# Conceptual Review Agenda

**Re:** 619 Grant Ave - Garage Conversion/Multifamily

**Description of project:** This is a request to convert an existing garage into a new dwelling unit and construct a storage/laundry structure at 619 S Grant Avenue (Parcel # 97142-10-026). The proposed storage & laundry structure would connect from the existing triplex to the converted garage, creating an overall structure containing 4 units. The site is located in the Neighborhood Conservation, Medium Density (N-C-M) Zone District. Multifamily dwellings are subject to Planning & Zoning Board (Type 2) review in the N-C-M district when structural additions are made.

**A1.0**  
 Conceptual  
 Revised Site Plan

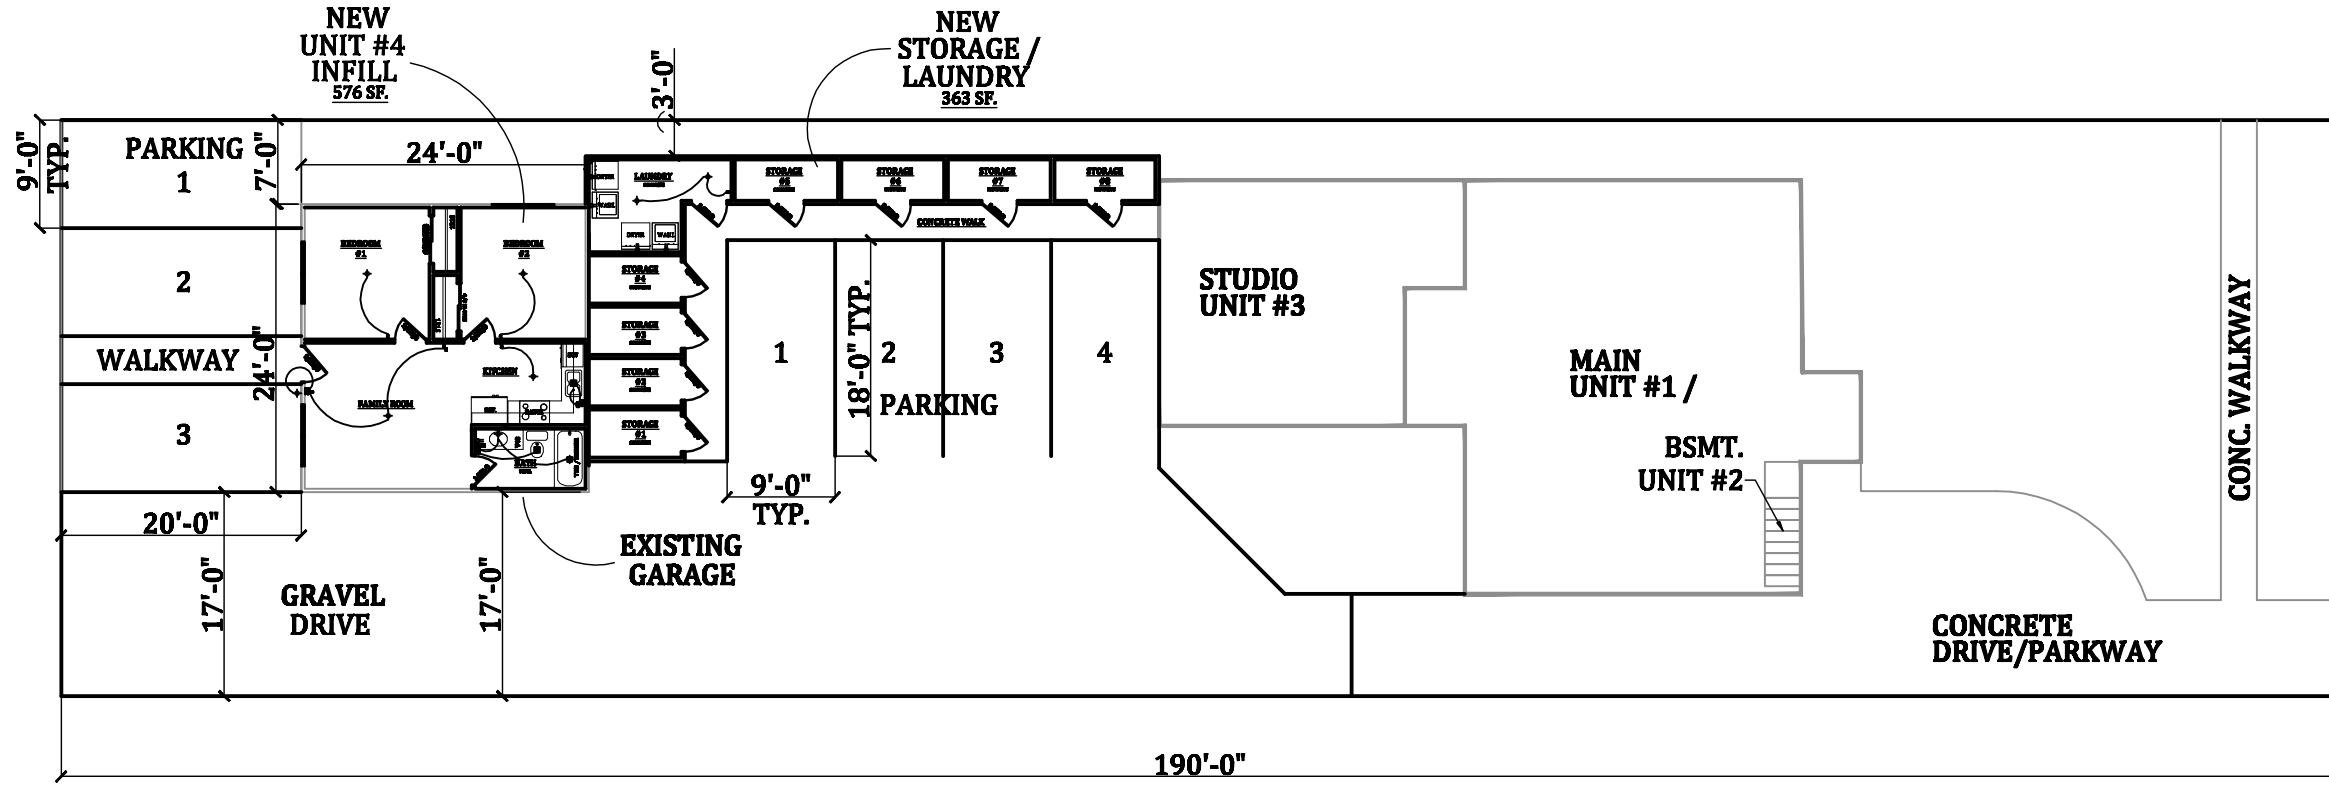
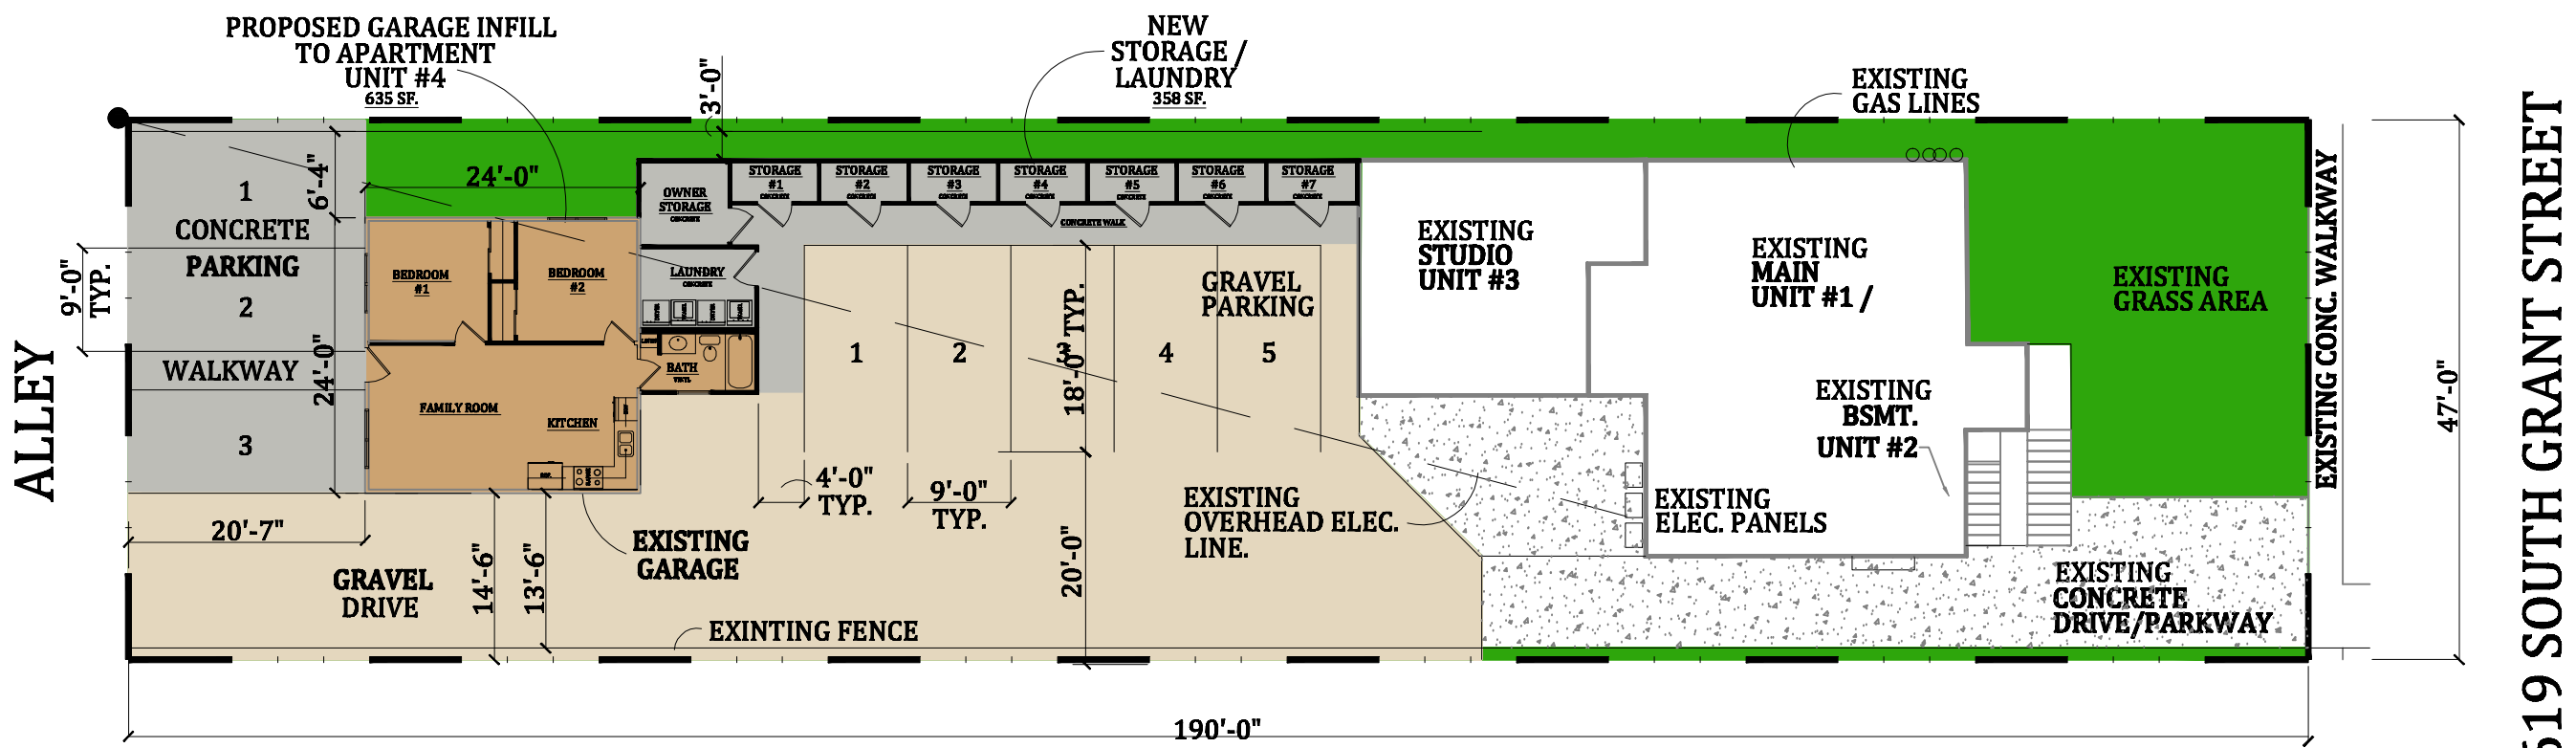
It appears that the proposed Floor Area exceeds the 40%. To exceed the allowable floor area would require a modification.

2. LUC 3.2.2(J) A landscape setback of 5ft is required from the vehicle use areas along the south and west property lines.

LUC 3.2.2(D)(3)(c) Vehicle use areas shall be surfaced with either concrete or asphalt.

3. LUC 3.2.2(K)(5) The required off street accessibility parking space is required to be van accessible (8ft wide loading area with 8ft wide stall). This space shall be as close to primary pedestrian entrance as possible and designated by a standard vertical sign.
4. LUC 3.2.5 An enclosure for both trash and recycling is required. Such enclosure shall be designed with

walk-in access without having to open the main service gate and located on a concrete at least 20ft from the public sidewalk.

The garage-to-residence conversion places the structure out of access and as such, a sprinkler system would be necessary to offset the access requirement. Also note, the sprinkler requirement may extend to the pre-existing tri-plex if the entire property is defined as one building. Further study is required.

6. The existing alley is not paved and with the proposal would need to be designed and constructed with paving in accordance to LCUASS abutting the property out to either Myrtle Street or Laurel Street.

8. Parking Access: Per 4.8(F)(5), Whenever a lot has frontage along an alley, any new off-street parking area located on such lot must obtain access from such adjoining alley.

9. Parking and drive isle dimensions: Long term parking stall dimensions are 18 x 8.5 minimum. At least one accessible space is required. Drive aisle width minimum is 24 feet for two-way traffic.
